**SUPPLEMENTARY REPORT
JOINT REGIONAL PLANNING PANEL
(Sydney West Region)**

JRPP No.:	2013SYW075 DA
Development Application No.	DA/725/2013 (Lodged 16 July 2013)
Description of Proposal:	Demolition of existing buildings, retention of heritage dwelling 'Strathnoon' and construction of a 125 bed residential care facility.
Property Description:	Pt Lot 1 DP 315877, No. 31 Pacific Highway, Wahroonga Lot 1 DP 780083 and Lot 2 DP 780083, No. 33 Pacific Highway, Wahroonga Lot 2 DP 800575, No. 2 Woolcott Avenue, Wahroonga Lot 2 DP 548937 No. 2A Woolcott Avenue, Wahroonga
Applicant:	Northside Constructions Pty Ltd
Owner:	Thompson Health Care Pty Ltd
Statutory Provisions:	State Environmental Planning Policy (Housing for Seniors or People with a Disability) 2004 State Environmental Planning Policy No. 55 Remediation of Land State Environmental Planning Policy (Infrastructure) 2007 State Environmental Planning Policy - Sydney Regional Environmental Plan No. 20 Hawkesbury-Nepean River Hornsby Shire Local Environmental Plan 1994 - Residential B (Medium Density) and Residential A (Low Density) zone

DA04

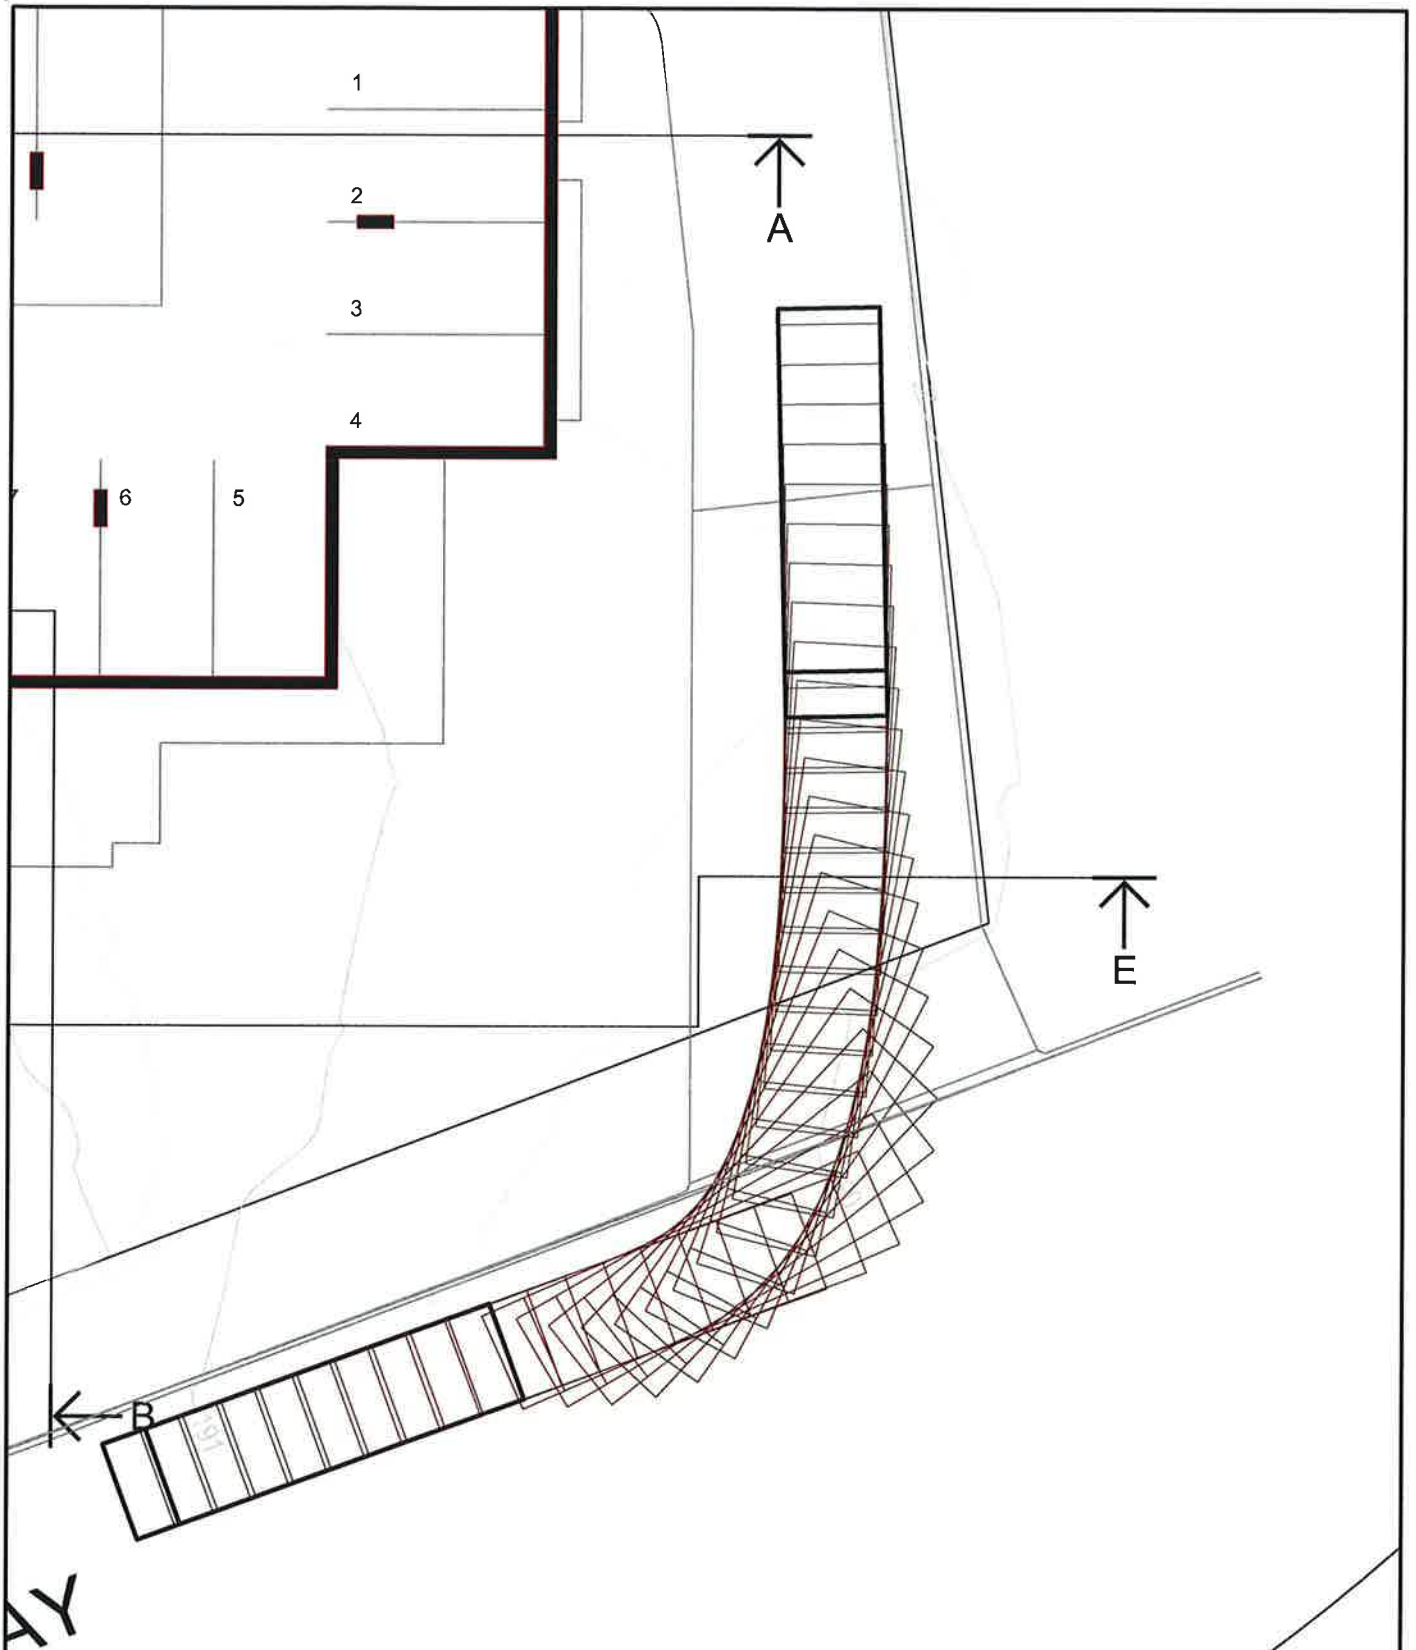
[REDACTED] raised concerns that the revised architectural plan does not provide landscaping to the western boundary as originally proposed which would provide visual and acoustic privacy to adjoining properties. Council is in receipt of Revision D of Plan No. DA04 which addresses the inconsistency with the submitted landscape plan and re-instates the area for landscaping to the western boundary. It is recommended that condition No. 2 in Schedule 1 of the report be amended to reflect this change.

I would like to object to the approval of this application. It appears to me that when the architectural plans were modified to enlarge the driveway/loading dock area that the landscaping plans needed to be updated.

The architectural plans submitted in July showed a gap between the western boundary and the driveway to accommodate the planting of hedging. The approved plans show the driveway fully against the property boundary at the north-west and western edges of the site. I believe that the newly submitted plans do not provide room for the planting shown in this area on the landscaping plans.

The original gap and plantings were to ensure that the visual and acoustic privacy of my property and those in McQuoin Park were protected. If these plantings are not present then I believe that I have a strong case to object on the grounds of visual and acoustic privacy.

Could you confirm whether the currently submitted architectural and landscaping plans are inconsistent in this area?

The recommended conditions in Schedule 1 have been incorrectly numbered. Accordingly, condition number 2 is to be renumbered to Condition No. 1 and amended to reflect the new plan number discussed in Section 2 above:

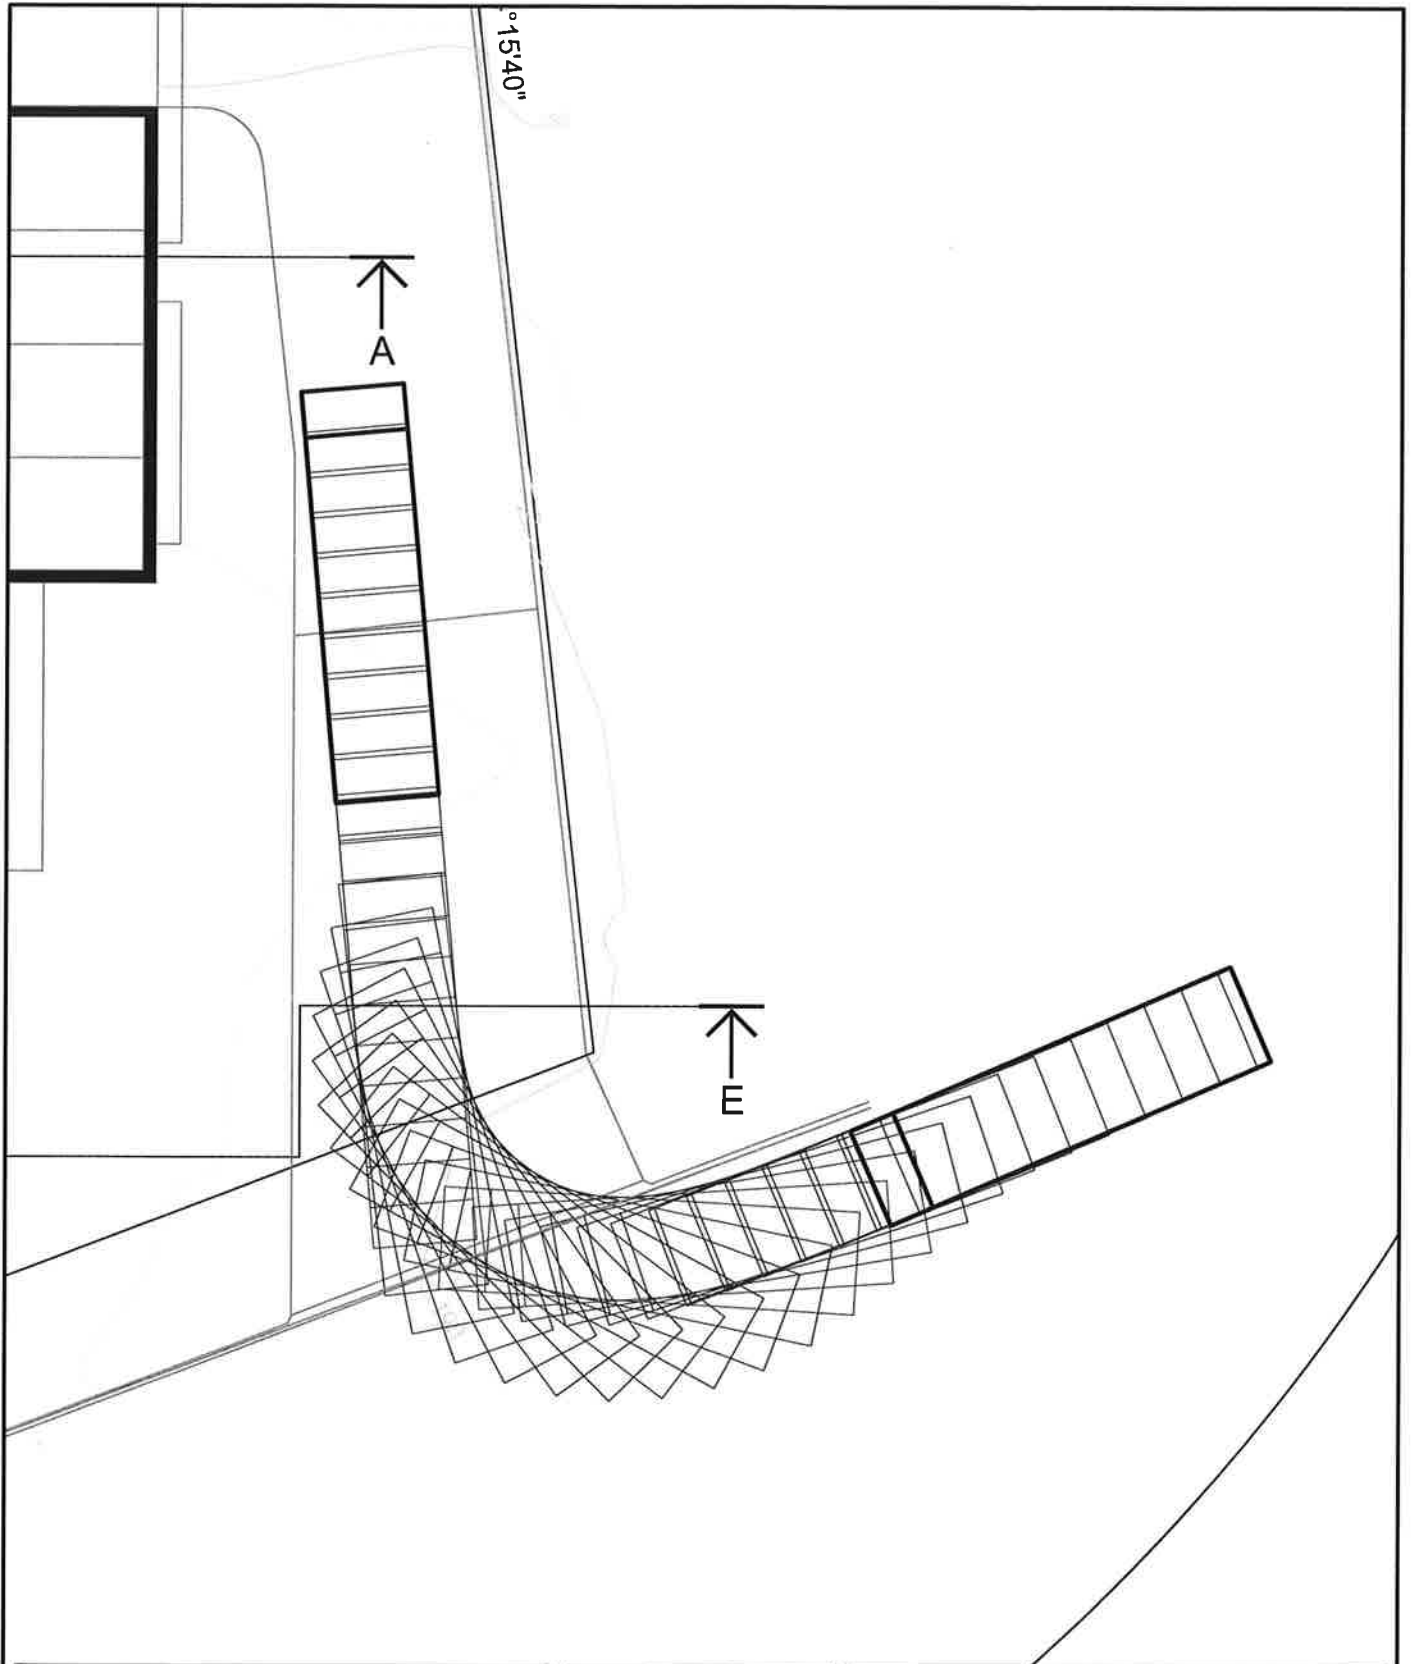
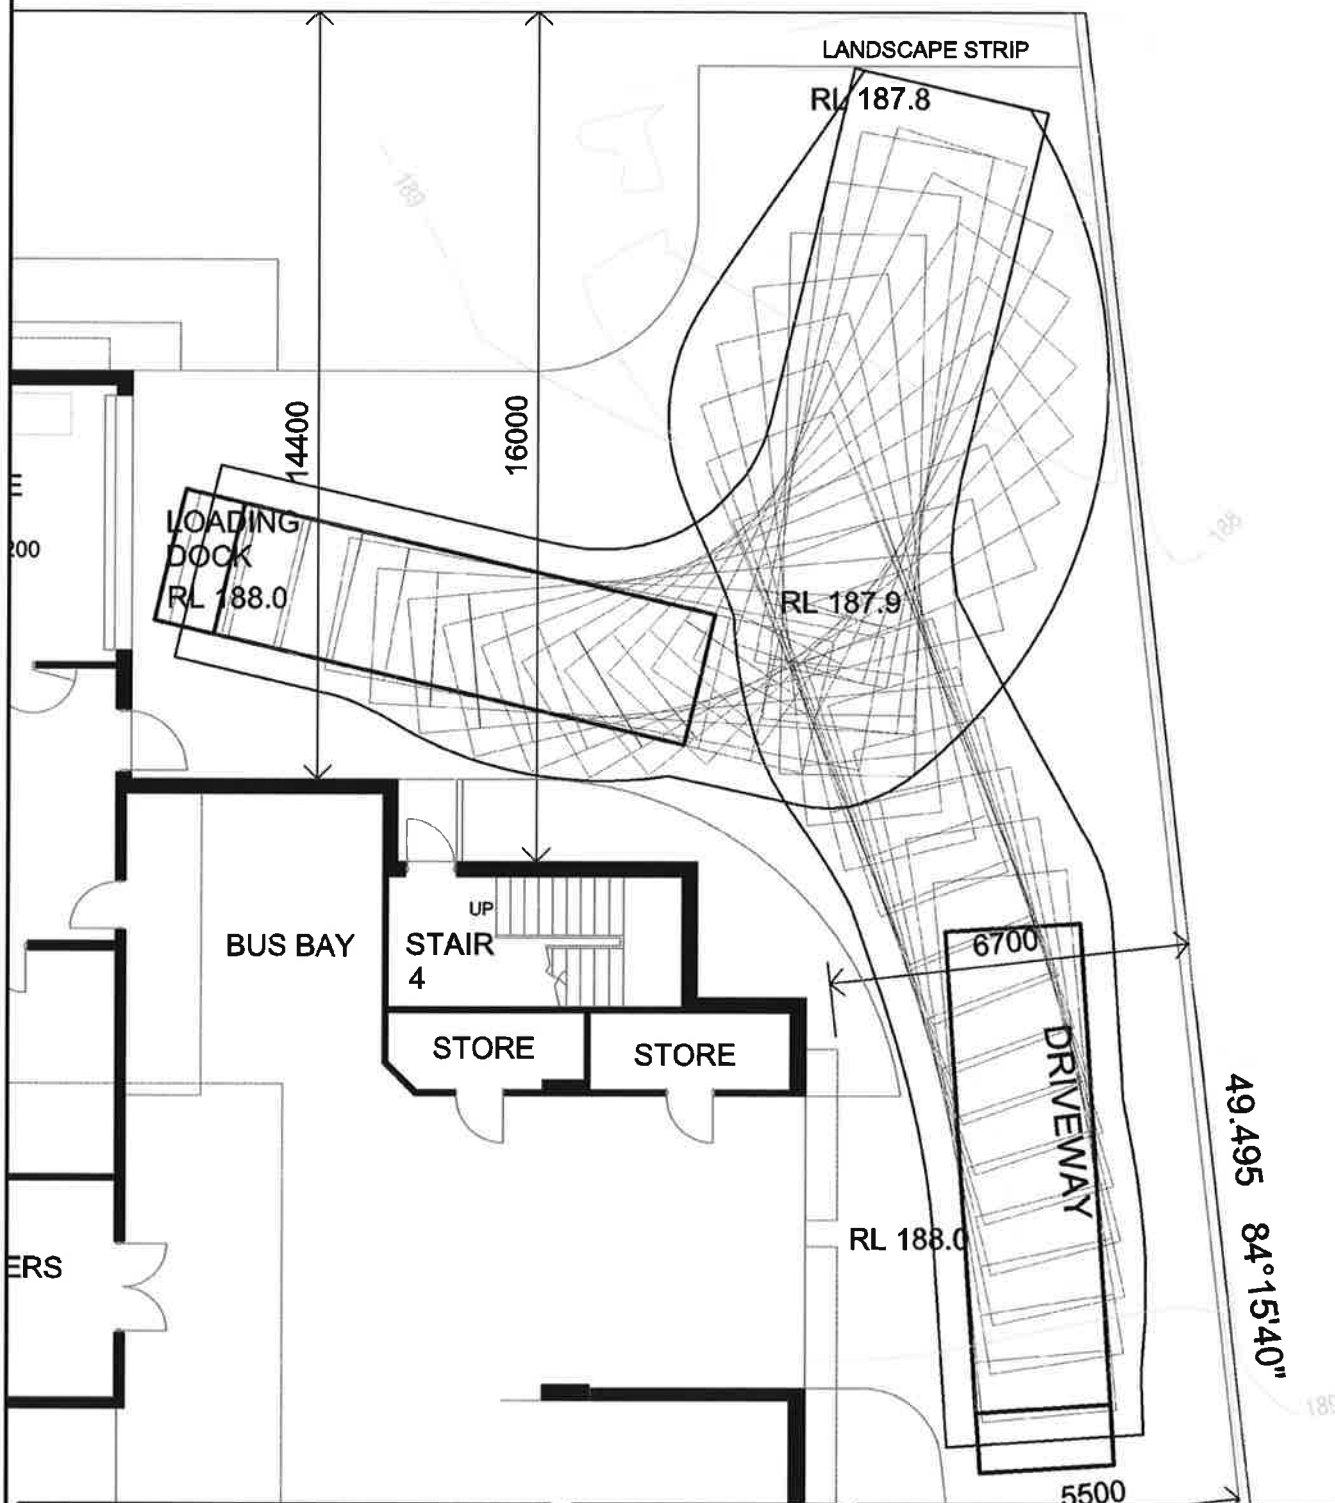
The submission also raised concern with regards to the swept path diagrams for the waste vehicle which is addressed in Point 3 below.

I have also not seen (on the council website) swept path diagrams for a 10.2metre waste disposal vehicle operating in the loading dock. The only diagrams I have seen for this type of vehicle are for entering and leaving on the Pacific Hwy. Have these diagrams been received? If so can they be put on the website? If they don't exist then perhaps they should be requested.

- The driveway has been amended to permit a 10.2m long vehicle to access the site and turning paths have been provided to demonstrate that the driveway and loading dock can service the Austroads 8.8m rigid truck with the ability to enter and leave in a forward direction at the Pacific Highway vehicular driveway. Council's traffic assessment notes that occasional service vehicle access to and from the Pacific Highway is considered acceptable and consistent with similar developments on State Roads in the Shire.
